Appendix D

Comments and Responses to Comments

Table D-1. Comments Received on the Oberon Draft EIR

Figure 1. BLM-designated multi-species wildlife linkages (shown in red) in DRECP LUPA/FEIS.

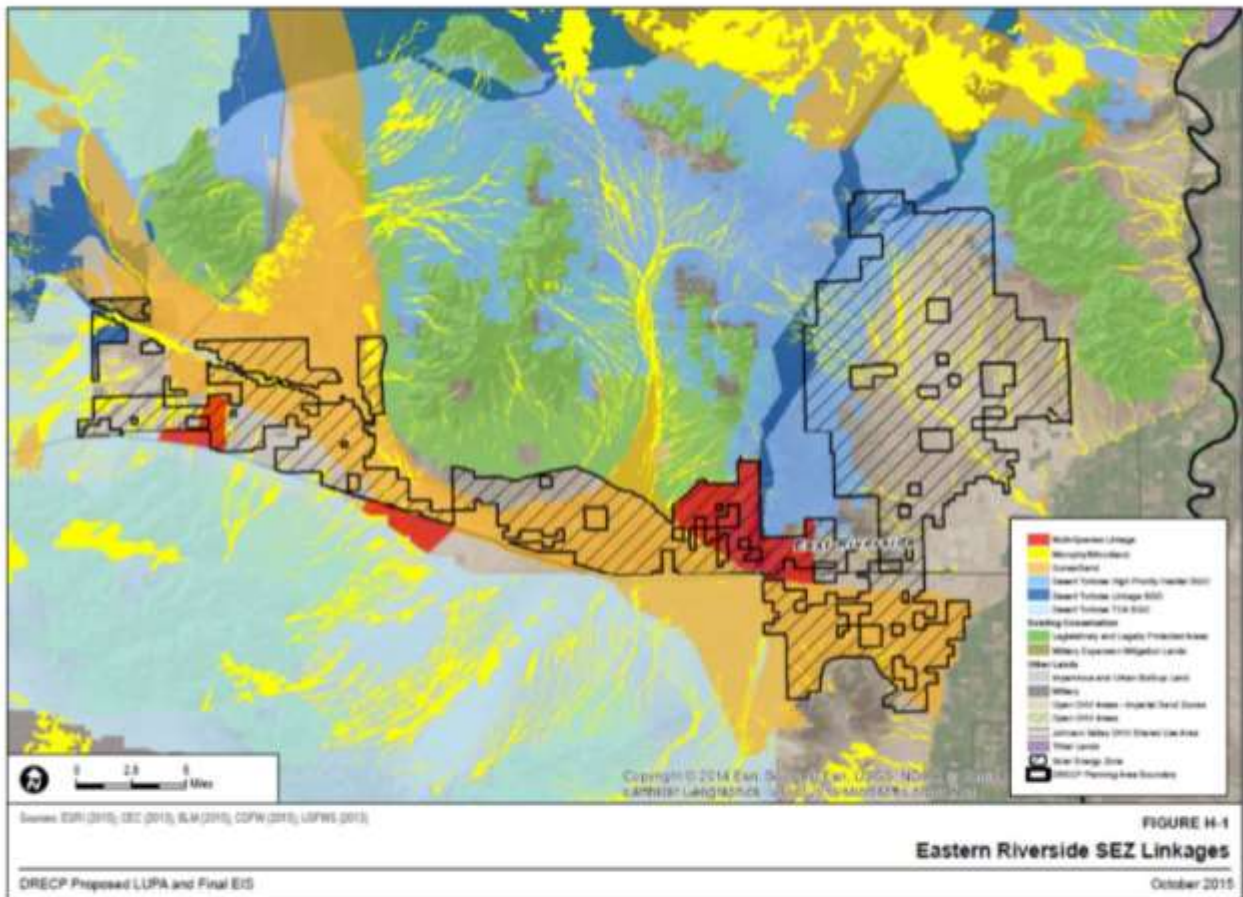
The Oberon EA fails to adequately analyze and mitigate impacts to the multi-species wildlife linkage and connectivity. Wildlife connectivity corridors and linkages are place-based areas that are often unmitigable if impacts occur in them (Spencer et al. 2010). The DRECP identified and established three wildlife connectivity corridors/linkages, two of them within the boundaries of the Riverside-East DFA (See Figure 1, taken from DRECP LUPA/FEIS, Appendix H-1).

Oberon is located partially within the most westerly wildlife connectivity corridor. Figure 1 shows the overlap of the proposed Oberon project's solar array field into the BLM-designated Wildlife Connectivity Corridor. The EA fails to identify the impact to the multi-species linkage from the proposed project. Based on GIS layers from the DRECP, the fenced solar arrays cover 325 acres of the multi-species linkage. In addition, it fragments the linkage, making the linkage less functional for wildlife to move unimpeded through it (Ibid). We recommend that the EA be revised to fully analyze impacts to the multi-species linkage and comply with the DRECP.

Figure 2. Proposed Oberon Project's overlap with BLM-designated Multi-species Linkage in the Riverside-East DFA.

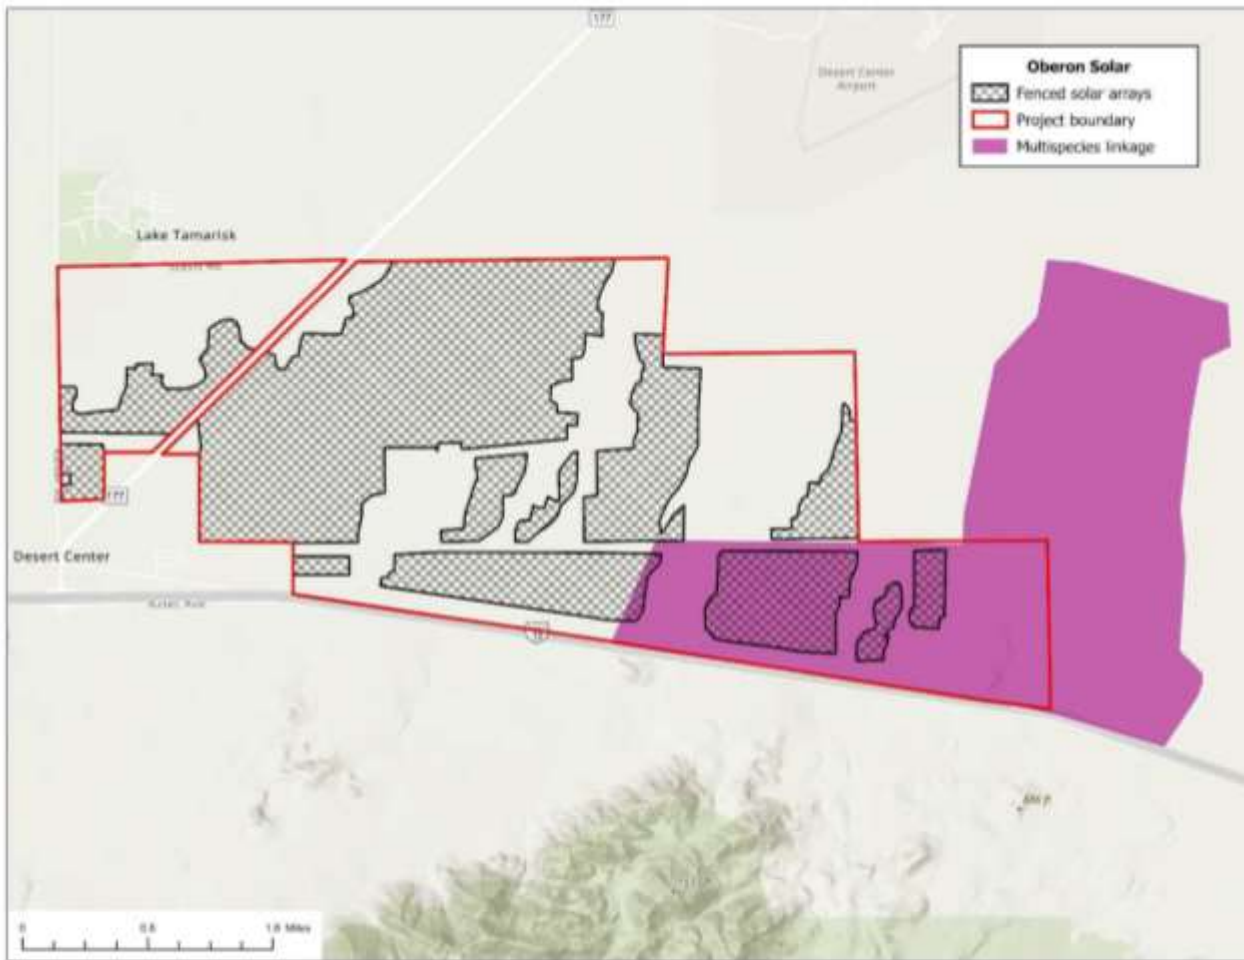
Figure 2.2 in Appendix B of the Oberon EA is troubling because it reveals the potential extent of cumulative impacts from other existing and proposed renewable energy projects in the western Chuckwalla Valley. One of those is the Easley Project, proposed by Intersect Power, which is also the proponent of Oberon. The Easley Project is located just to the north of the Athos and Victory Pass projects. Victory Pass would impact the multi-species linkage by placing solar arrays within the linkage. The Athos project, which is not on BLM-managed land and is currently under construction, has already constricted over half of the northern part of the linkage on the west. The proposed Easley project's southern or northern areas have the potential to block the northern part of the linkage, thereby completely eliminating the functionality of the multi-species linkage. BLM must comply with the DRECP and maintain the wildlife linkages and analyze all the known direct, indirect and cumulative impacts to the multi-species wildlife linkage.
